**Final Staff Report Including the Final Substitute Environmental Documentation
Adopted May 6, 2015**

Amendment to the Water Quality Control Plan
For Ocean Waters of California

DESALINATION FACILITY INTAKES, BRINE DISCHARGES, AND THE INCORPORATION OF
OTHER NON-SUBSTANTIVE CHANGES

May 6, 2015

Figure 2-1 Existing coastal desalination facilities in California.

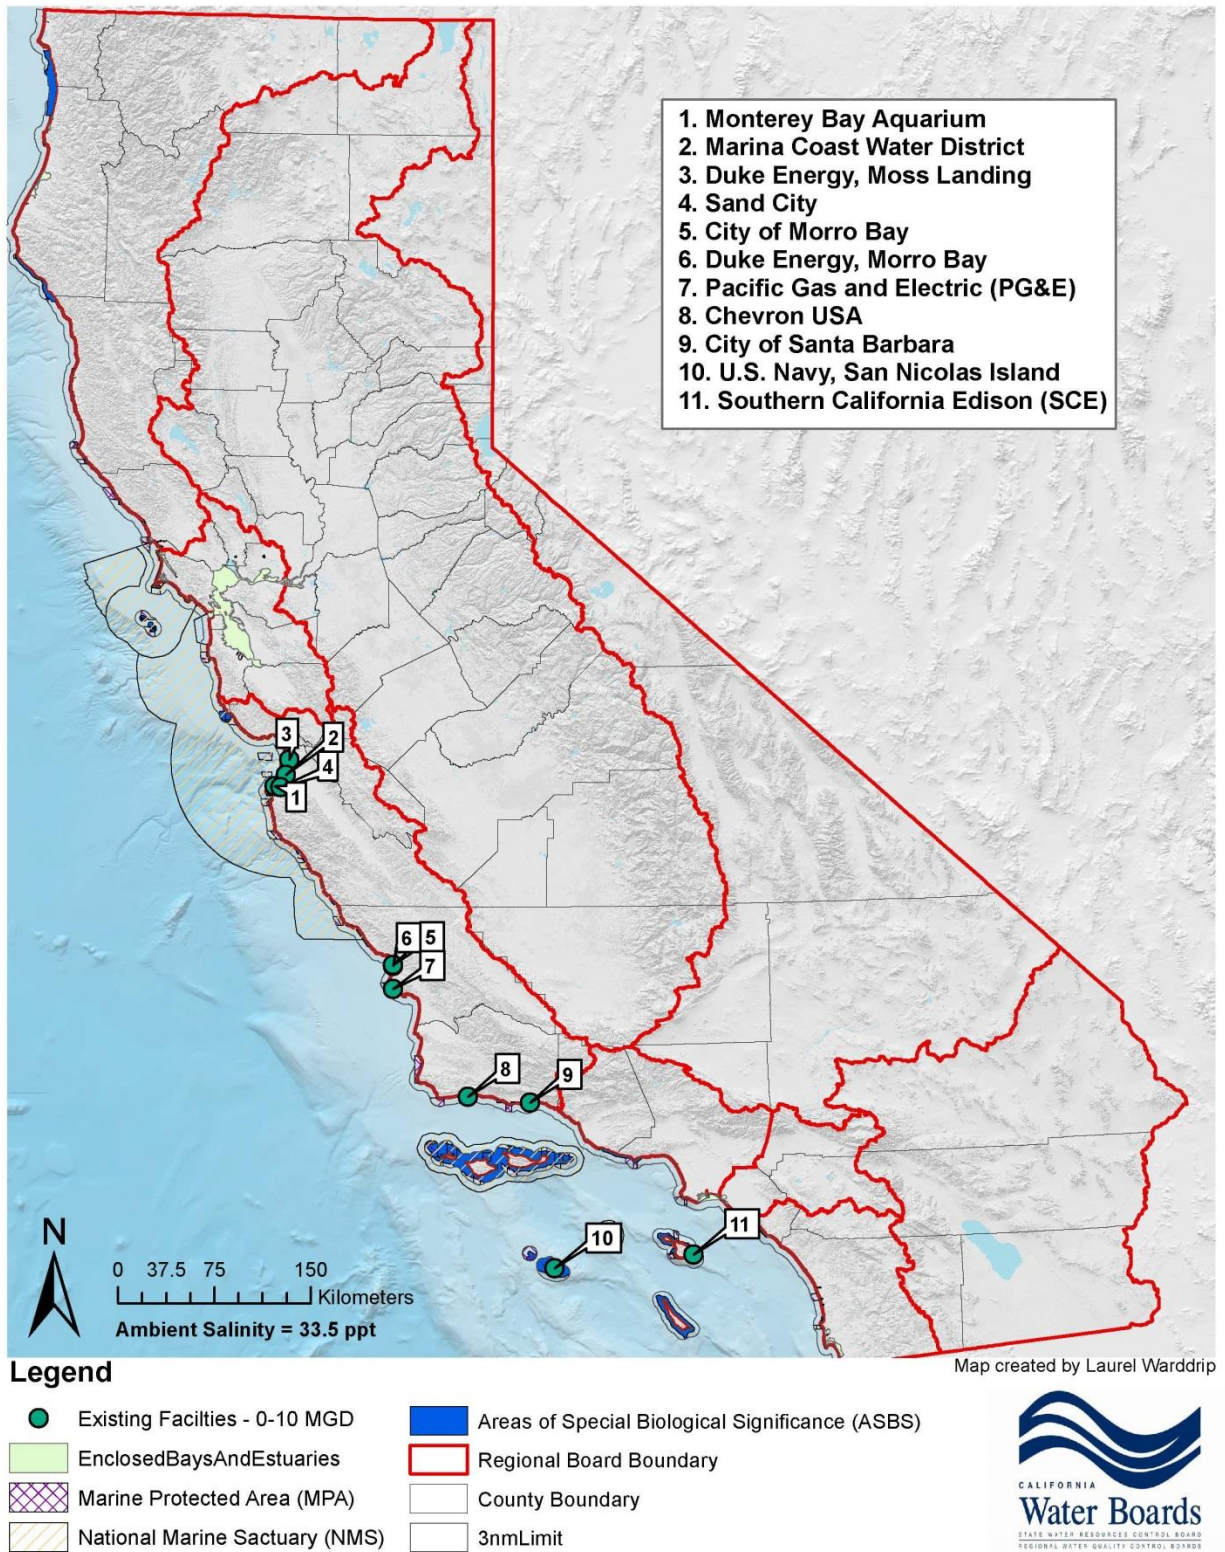
16.2	Figure 2-1, Page 15 [of the Staff Report with SED]: Include the Sand City BWRO on Figure 2-1 Existing coastal desalination facilities in California. The latitude and longitude of the Sand City BWRO facility is: 36d36'41.09"N, 121d51'16.92"W and is located as shown below: [see comment letter]	Figure 2-1 was based on information from Cooley et al. 2006 and has since been updated based on the information provided in this comment.

Figure 2-2. Proposed desalination facilities in California as of 2014.

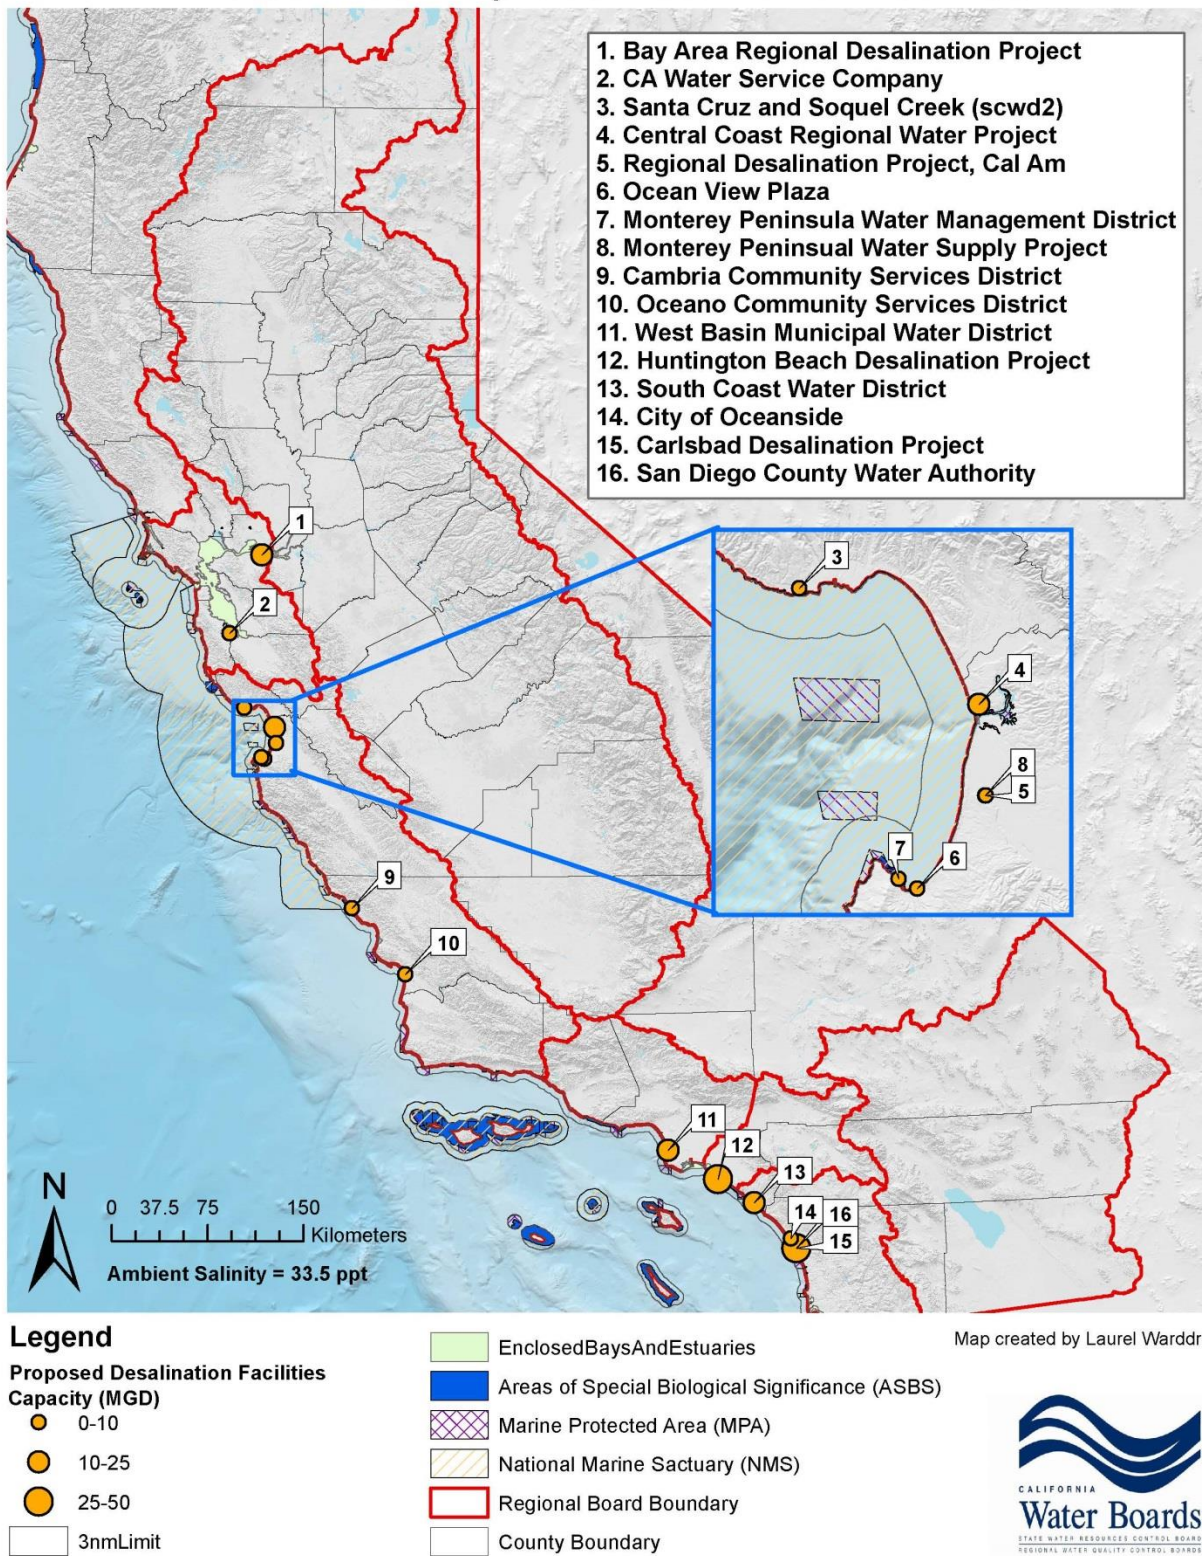
16.5	Figure 2-2, Page 18 [of the Staff Report with SED]: Include the MPWSP on Figure 2-2 Proposed desalination facilities in California as of 2014. The latitude and longitude of the MPVSP desal plant is: 36d42'54.86"N, 121d46'22.11"W and is located as shown below: [see comment letter]	Comment noted. Table 2-2 was based on information from Cooley et al. 2006 and has since been updated based on the information provided in this comment.

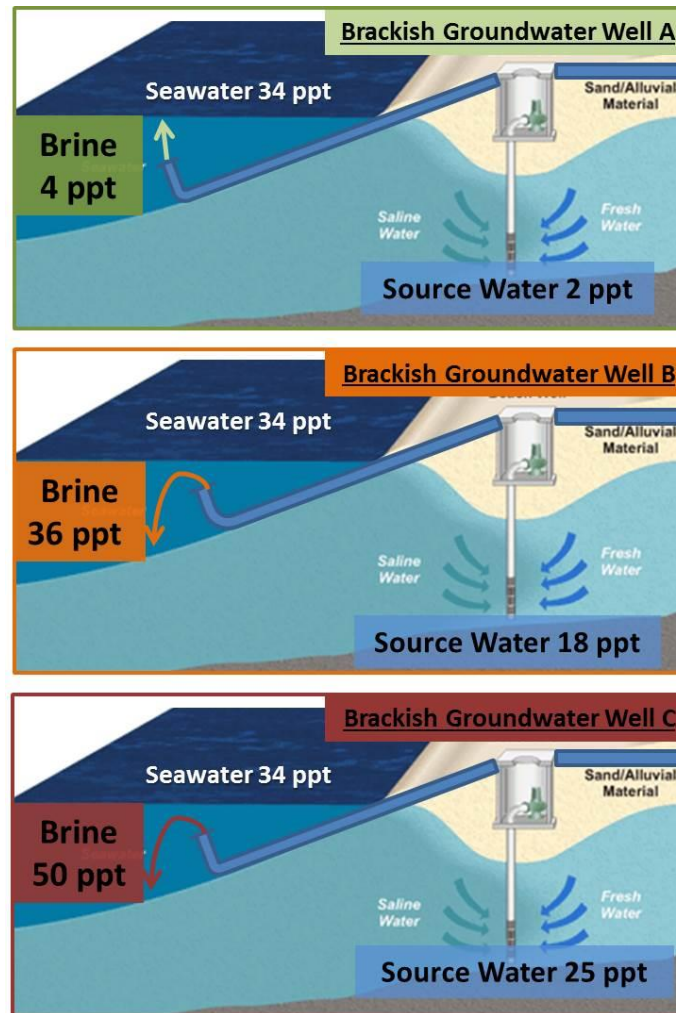
ID#	Comment Summary	Response
		for salinity that would apply to all brackish groundwater desalination facilities in California. Figure 8.1-1 below presents three brackish groundwater desalination facilities with different source water and brine salinities measured in ppt. The figure illustrates how varying salinity of source water can influence the density of the discharged plume. Facility A produces a positively buoyant "brine" plume that would not affect the benthic marine environment. Facilities B and C would form dense, negatively buoyant plumes that could negatively affect the benthic marine environment if not properly discharged. Currently, regional water boards issue waste discharge permits (either WDRs or NPDES permits) for brackish water desalination facilities on a case-by-case basis. More research is needed to identify an appropriate statewide limitation to apply to brine discharges from brackish groundwater desalination facilities. The Staff Report with SED does not adequately study brackish groundwater desalination facilities and staff would need additional time to research the impacts associated with the facilities and incorporate the information. Furthermore we would need to meet with stakeholders in the brackish groundwater desalination facility community to solicit feedback on the proposed Desalination Amendment language. Brackish groundwater desalination facilities are currently regulated by the regional water boards on a case-by-case basis. However, if there is sufficient public interest the State Water Board may address the issue in a subsequent amendment to the Ocean Plan.
